# **ILC Cryogenics Layout:**

## A draft consensus for the Change Request

CFS and Cryogenics Two-days  
Workshop at CERN  
27 and 28, July, 2015

## Main Cryogenics Layout on Surface

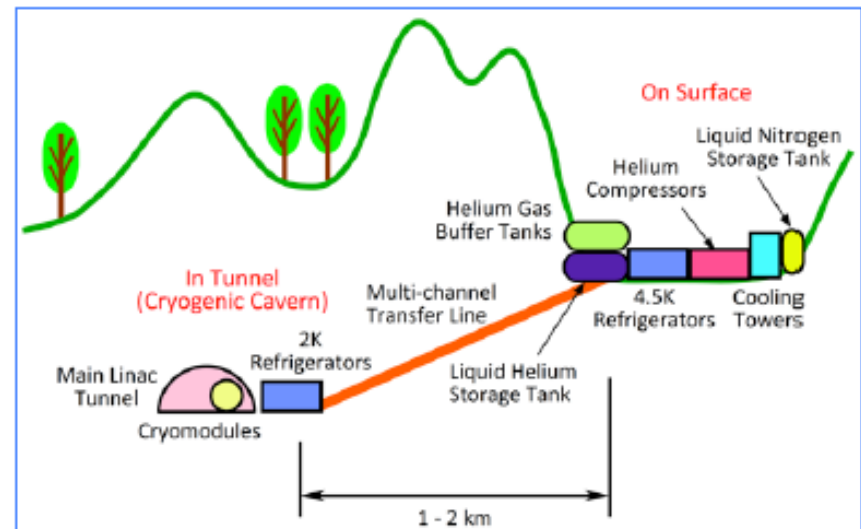
ILC-TDR Baseline

New Baseline to be proposed to CMB

- Safety
- Accessibility in daily operation
- No concern for MC vibration
- He storage flexibility
- Smaller access tunnel size because of no installation of 4.5 K Cryo-plant Under G.
- A cost drivers:
- Saving caver cost:
  - 23,000m<sup>3</sup>x 0.5 = ~ 11,500 m<sup>3</sup>
  - 200 CHF/m<sup>3</sup> x 2.30E4 = 2.3 MCHF
- Additional transfer line cost:
  - 2 kCHF/m x 1,000 m = 2 MCHF

- All cryogenic components except 2 K refrigerators and distribution boxes will be installed on surface
- Cryogenic components on surface and underground will be connected with multi-channel transfer lines
- Consideration of scenic preservation for cryogenic components on surface is necessary
- Cost can be reduced by constructing 10 identical cryogenic plants for main linacs
- Distribution boxes of two adjacent cryogenic plants may be interconnected for redundancy (but higher cost)
- Number of cryo strings for 1 cryo unit should be fixed to 21
- Total length of multi-channel transfer lines differs according to location
- Construction cost should be re-evaluated as cryogenic configuration change
